SERVICE BULLETIN

M1640 (REV A): COOLING SYSTEM ENHANCEMENT FOR 2024 CENTER COOLED TOURING MODELS

M1640

Figure 1. Original Coolant Pump

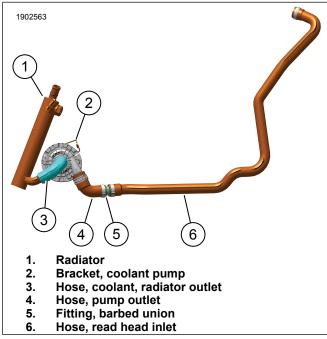
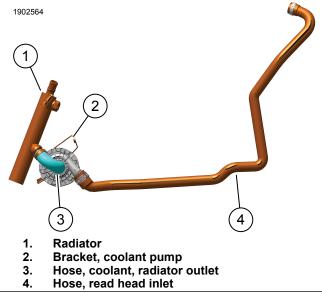
See Figure 1 and Figure 2. How to identify the changes in the parts:

- The radiator outlet fitting location was changed from low to high.
- The coolant pump bracket was changed to lower the overall pump position. This improves the purging and helps any air pockets that could be trapped at the inlet of the coolant pump to move upward into the radiator.
- The coolant hose that goes from the coolant pump to the rear head inlet has improved geometry and no longer contains a union fitting.

If any part that **has gone obsolete** in Table 2, then the entire coolant system assembly **must be replaced** with the later version. See Table 3 and Figure 2.
